MIAMI BEACH

Staff Report & Recommendation

Design Review Board

SUBJECT: DRB21-0686
2464 Prairie Avenue

Mid-Golf Subdivision of Miami Beach Bay Shore Company. February 1920

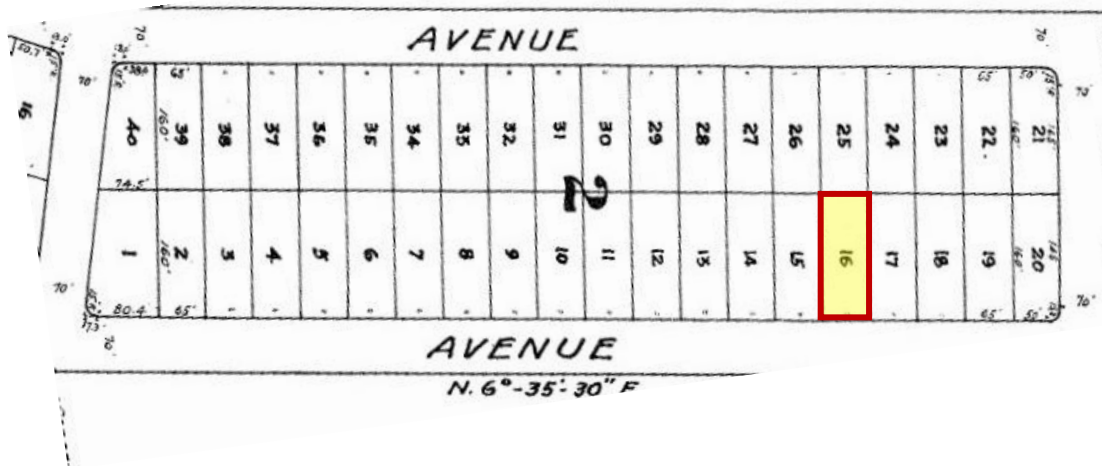
The applicant is proposing a new two-story single-family home that exceeds the maximum lot coverage and unit size allowed. The property is an interior lot containing 10,400 sf of area with a lot width of 65'-0". The subject lot exceeds the minimum size of 10,000 sf and minimum lot width of 60'-0" required for the RS-3 district. This property size is consistent and similar to all surrounding properties within Block 2 of the Mid Golf Subdivision, as noted in the original plat map below. The applicant's letter of intent indicates that the "narrow lot and the proximity to adjacent neighbors" present challenges for the design of the home.

However, based on the size and location of the property and the fact that this is new construction, staff finds that there are no special conditions on this property for the variances requested and the approval of these variances would confer a benefit to the applicant denied to other surrounding properties. The variances requested are not the minimum variances required to make a reasonable use of the property.
